Subject: 2019 ISO LCR Study Criteria -- Methodology and Assumptions

Submitted by	Company	Date Submitted
<i>Michele Kito 415-703-2197 Jaime Rose Gannon</i>	<i>Energy Division California Public Utilities Commission</i>	<i>November 14, 2017</i>

The CPUC Staff appreciate the opportunity to comment on the California Independent System Operator (CAISO) Draft Manual, 2019 Local Capacity Area Technical Study and the October 31, 2017 presentation entitled, “2019 Local Capacity Technical Study Criteria – Methodology and Assumptions.” Energy Division Staff comments are summarized below:

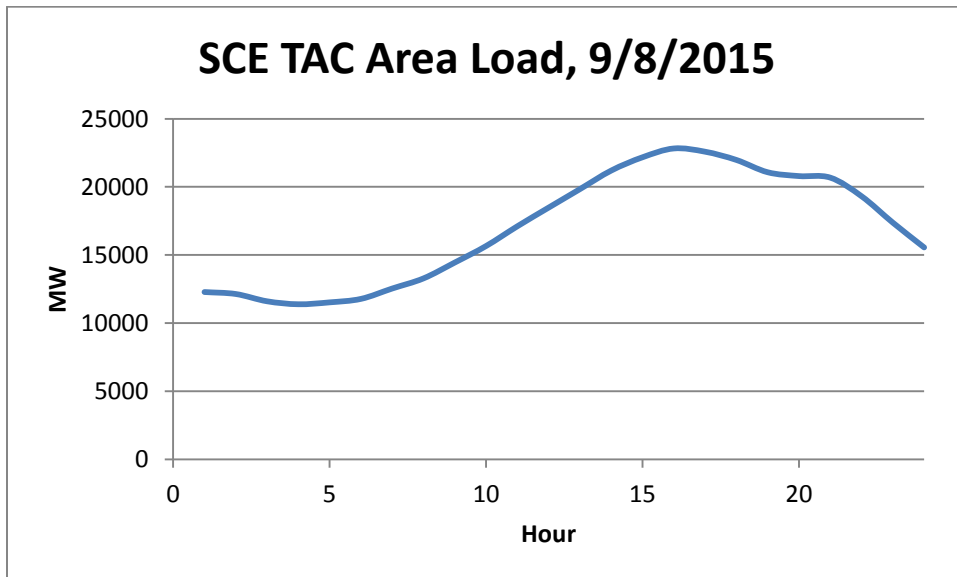
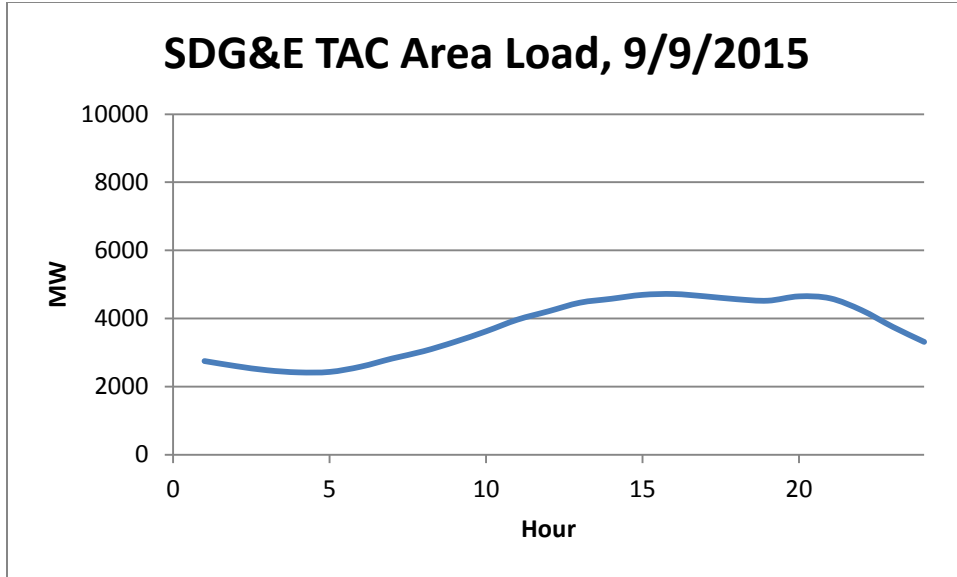
Energy Division staff believes that CAISO’s previous methodology, of adding back in all of the behind-the-meter generation to the CEC’s base case forecast would be flawed and would overstate the loads in these areas. CAISO’s methodology is flawed because it does not take into consideration the fact that consumption loads decline by 6 p, so adding behind-the-meter generation that occurs during the 4 pm peak to the 6 pm hour will result in a higher load than will be seen at the 6 pm hour. This is illustrated in the figures below.

As illustrated, for the SCE TAC area, if PV is added back in at 4 pm, this will vastly overstate the sales load at both the 4 pm and certainly the 6 pm hour. Moreover, the CAISO’s peak shift adjustment is likely even more problematic for the combined area, for which the peak is likely to be driven by the SCE area. In sum, given the shape of these sales load curves, we believe that CAISO’s peak shift adjustment used for 2017 is likely to be flawed and this methodology should not be used in the 2019 study.
